**SOLICITATION AMENDMENT**  
**MODIFICATION DE L'INVITATION**

<b>Title - Sujet</b> Courtyard lighting upgrades Ste-Ann	
<b>Solicitation No. - N° de l'invitation</b> 21301-144397/A	<b>Amendment No. - N° modif.</b> 001
<b>Client Reference No. - N° de référence du client</b> 21301-14-4397	<b>Date</b> 2013-11-25
<b>GETS Reference No. - N° de référence de SEAG</b> PW-\$MTC-480-12474	
<b>File No. - N° de dossier</b> MTC-3-36293 (480)	<b>CCC No./N° CCC - FMS No./N° VME</b>
<b>Solicitation Closes - L'invitation prend fin</b> <b>at - à 02:00 PM</b> <b>on - le 2013-12-05</b>	
<b>F.O.B. - F.A.B.</b> <b>Plant-Usine:</b> <input type="checkbox"/> <b>Destination:</b> <input checked="" type="checkbox"/> <b>Other-Autre:</b> <input type="checkbox"/>	
<b>Address Enquiries to: - Adresser toutes questions à:</b> Belisle (mtc480), France	<b>Buyer Id - Id de l'acheteur</b> mtc480
<b>Telephone No. - N° de téléphone</b> (514) 496-3881 ( )	<b>FAX No. - N° de FAX</b> (514) 496-3822
<b>Destination - of Goods, Services, and Construction:</b> <b>Destination - des biens, services et construction:</b>

Included: Addendum E 01

November 22<sup>nd</sup> 2013

**3.4 DRAWINGS E04 OF 04**

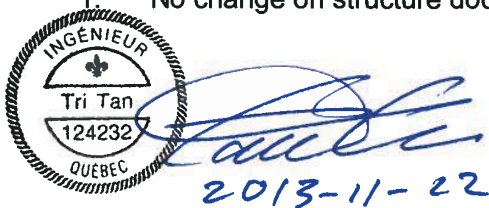
1. The use of Teck cables is not permitted inside the building.
